# NORTHWORKS Hunt Residence ARC -24-0106 ZON-24-0063 260 Colonial Ln, Palm Beach, FL 33480

# NORTH ELEVATION

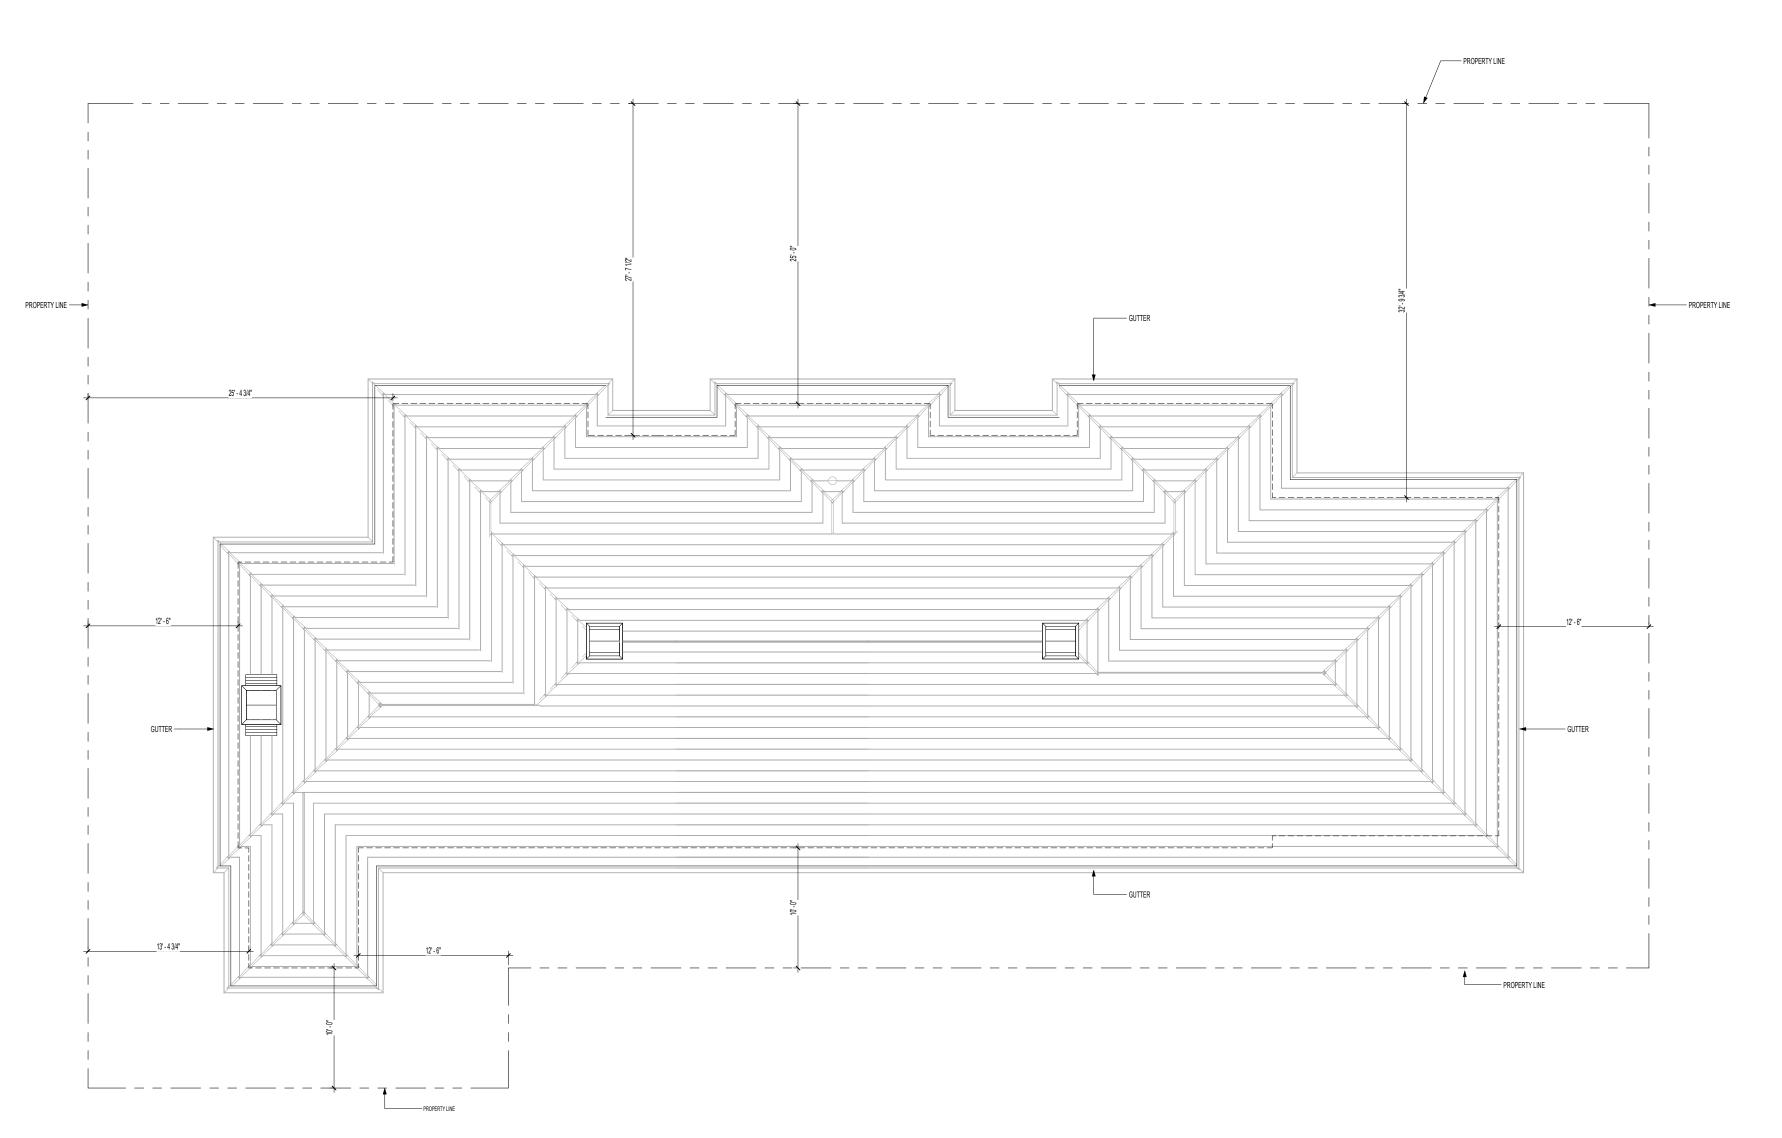
# COMMENT 5- STUDY WINDOW SCALE AND PLACEMENTS ON NORTH FACADE

# RESPONSE: WE HAVE STUDIED THE DIVISIONS ON THE WINDOWS AND MADE SURE THEY ARE THE SAME SCALE. WE ALSO STUDIED THE PLACEMENT OF THE WINDOWS BUT BELIEVE THAT THE PREVIOUSLY PROPOSED LOCATION WORKS BEST.
